EEE Modifications

P802.3bj comments 249, 250, 251

*P802.3bm – address one obstacle to adopting an
EEE objective*

Figure 78-3—Overview of EEE LPI operation

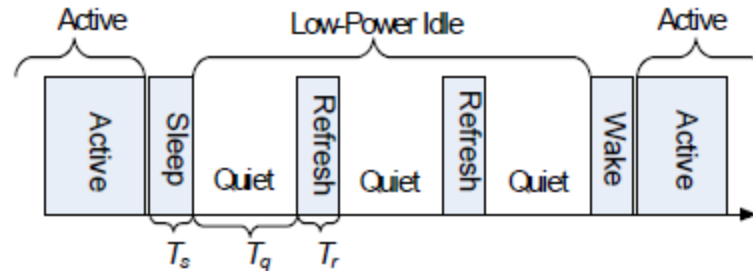
- Page 54, line 45, clause 78.5 – Terminology is misleading – there aren't two kinds of wake, there are two kinds of sleep. The new kind of sleep does not follow the flow indicated in Figure 78-3 of the base document and requires another figure.
- Page 58, line 29, clause 80.1.2 - OTN Support – While P802.3bj does not have an OTN support objective, it is making non-backward compatible changes to P802.3ba interfaces causing them to fail to meet the OTN support objective. In addition, hope to reuse P802.3bj PCS changes for EEE should P802.3bm adopt EEE objectives
- Page 83, line 5 – Rapid Alignment Marker insertion is only needed for refresh and wake phases of normal wake operation and should not be used for “fast wake” as this prevents the PCS with EEE from being used for 40 Gb/s and 100 Gb/s optical interfaces

- With what has been called “fast wake”, there is no Quiet period since the transmitter is left on. Refresh is implicit. There is no “Sleep” signal before the transmitter goes quiet. T_s , T_q , T_r are all irrelevant

Figure 78-x-Overview of EEE without turning off Transmitter

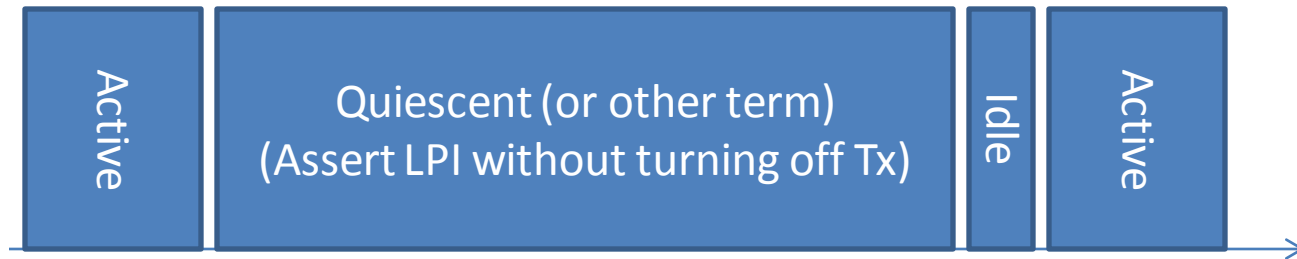
- Note that Rapid Alignment Markers are needed for the “Refresh” and “Wake” steps of what has been called the “Normal Wake” process of Figure 78-3. They are not needed at all for the process of Figure 78-x which can simply send LPI control characters while maintaining alignment with normal alignment spacing

- Replace “Normal Wake” and “Fast Wake” terminology with something more appropriate to describe the sleep state where the Tx is still on asserting LPI
- Insert a warning that “Normal Wake” (or the new name) EEE operation must be disabled for signals transparently mapped over OTN
- For “Fast Wake” (or the new name) quiescent state, change this operation to send LPI control characters while maintaining normal lane alignment markers to preserve compatibility with OTN mapper

OTN Mapping for 40GBASE-R and 100GBASE-R

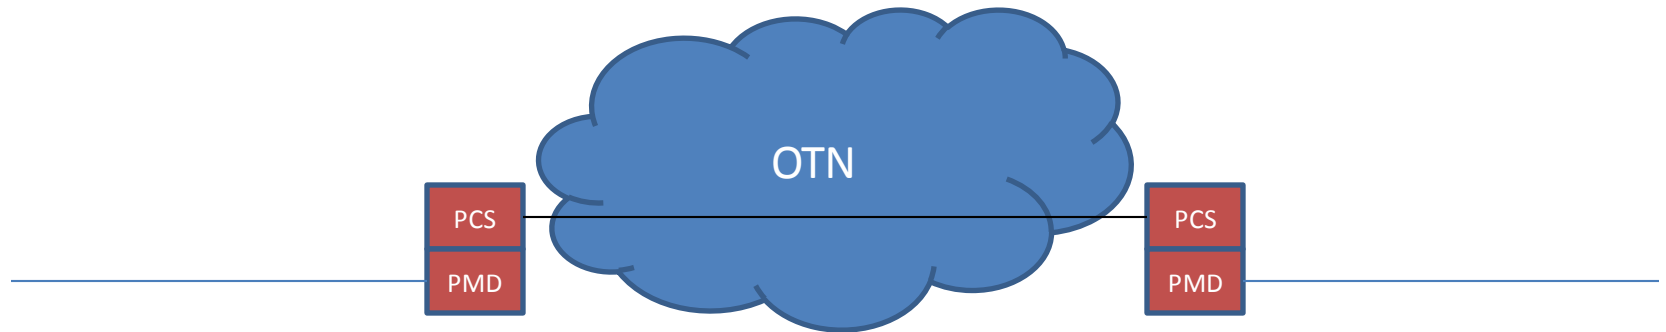
- Transparent (PCS) and non-transparent (MAC/GFP) mappings
- What is mapped is the PCS output, allowing different PMDs to be used at the OTN ingress/egress
- Restricted to 66B codeword set of Table 82-5 to permit 1024B/1027B transcoding of 40GBASE-R to fit OPU3
- PCS lane recovery and deskew so that combined ingress/egress links do not exceed the skew budget. Lane recovery in G.709 uses block diagrams from Figures 82-10, 82-11 of approved IEEE Std 802.3-2012 to recover the PCS lanes

Current “fast wake” process not compatible with OTN mapper

- In the current “fast wake” process the position of the alignment markers is different after the LPI section than it was before the LPI section
- The new alignment marker position is related to the point that the signal transitions from LPI
- This means that the mapper has to follow the RAMs so as to re-acquire the position of the normal alignment markers even though the alignment hasn't changed (the transmitter and receiver have been on continuously)
- This is a major change to the OTN mapper / demapper processing without any alignment issue being fixed

Possible EEE support for PCS codeword transparently mapped Ethernet

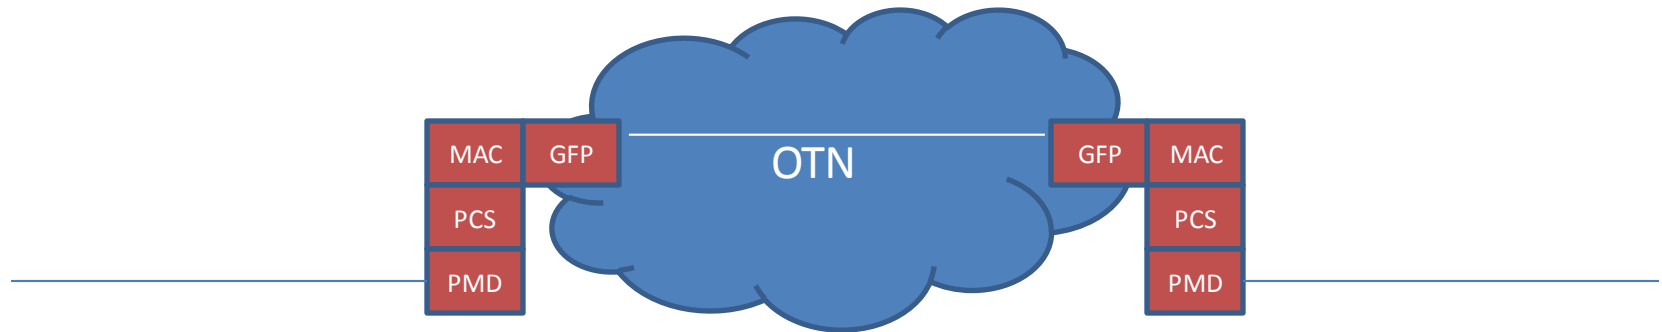
- “Fast Wake” (or better terminology) only
- OTN mapper unaware of EEE
- EEE capability exchange between Ethernet endpoints transparently across the OTN (as if the connection were point-to-point)
- LPI assertion during quiescent period passed transparently over the OTN without change to PCS lane framing
